Application for a licence amendment

Licence number	L8752/2013/2
Licence holder	Woodside Burrup Pty Ltd
ACN	120 237 416
File number	2013/002356-2
Premises	Pluto Liquefied Natural Gas (LNG) Project Lot 384 Deposited Plan 220146, Lot 572 on Deposited Plan 28209 and Lot 574 on Deposited Plan 28209 BURRUP WA 6714 as depicted in Schedule 1
Date of report	11 February 2025
Decision	Revised licence granted

1. Decision summary

Figure 2. Proposed modified RTO arrangement.

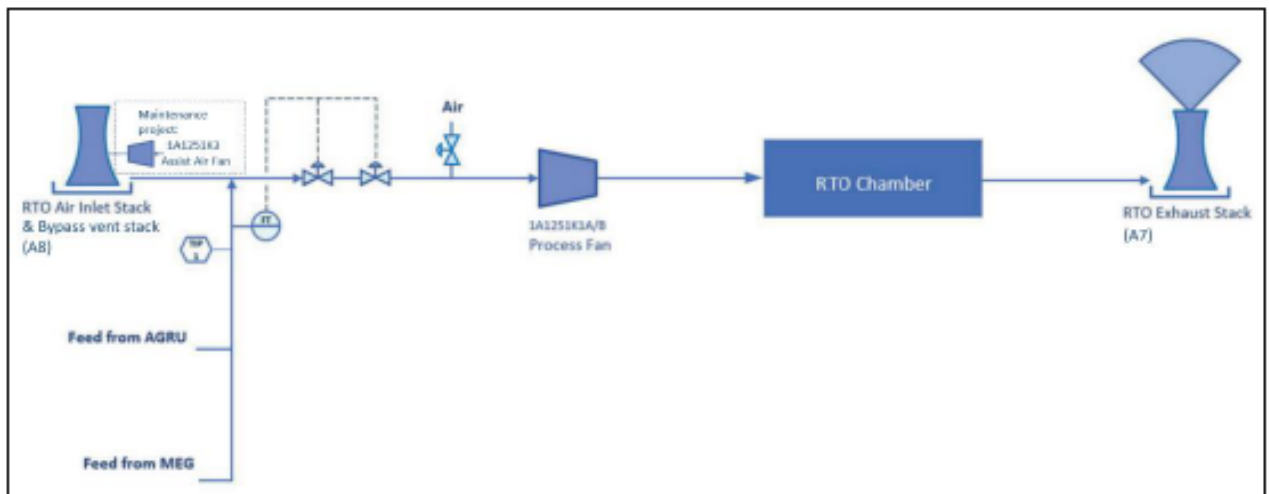
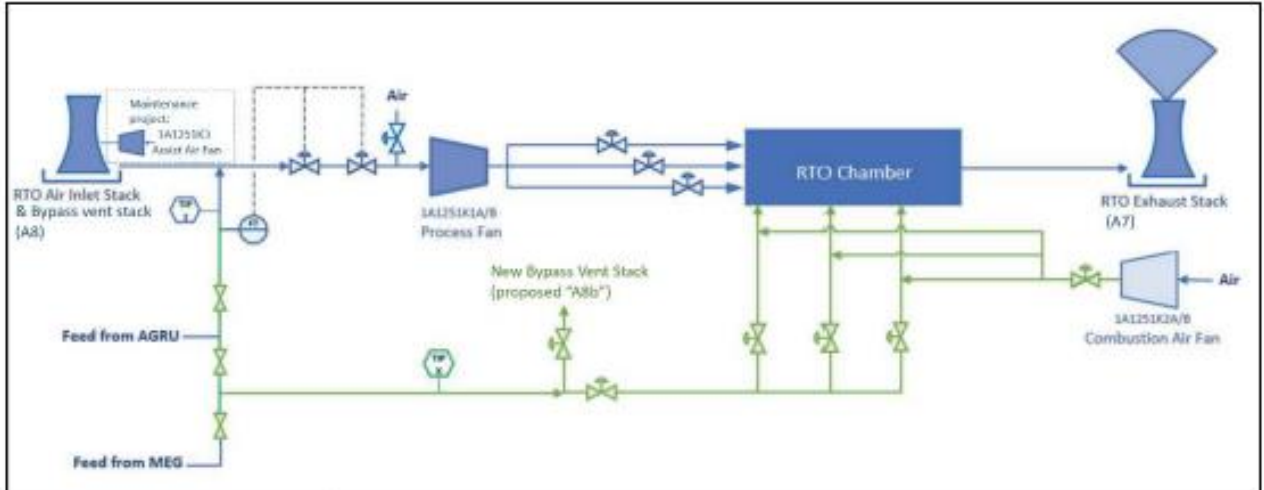
Proposed modifications	
1.	Installation of new piping, blower and instrumentation to enable Acid Gas Removal Unit (AGRU) off-gas and MEG storage off-gas to be directly injected to the RTO combustion chamber.
2.	Installation of a new smaller diameter vent stack (A8b) for the disposal of waste streams from the AGRU and MEG storage for use when the RTO is offline/unavailable
3.	Modifications to the RTO control, instrumentation, safety/emergency relief vents and safeguarding system.

The licence holder therefore proposes to install a second smaller diameter bypass vent (emission point A8b) adjacent to the existing bypass vent stack. The new bypass vent will be at least 30 metres high and 110 mm in diameter in order to ensure adequate dispersion of the off-gases is achieved. Associated with these works the licence holder will also install infrastructure to direct AGRU and MEG storage off-gases directly to the RTO combustion chamber and will make modifications to the RTO control, instrumentation, safety/emergency relief vents and safeguarding system to ensure safe and reliable operation of the RTO combustion systems to limit the frequency and duration of use of the RTO bypass vents.
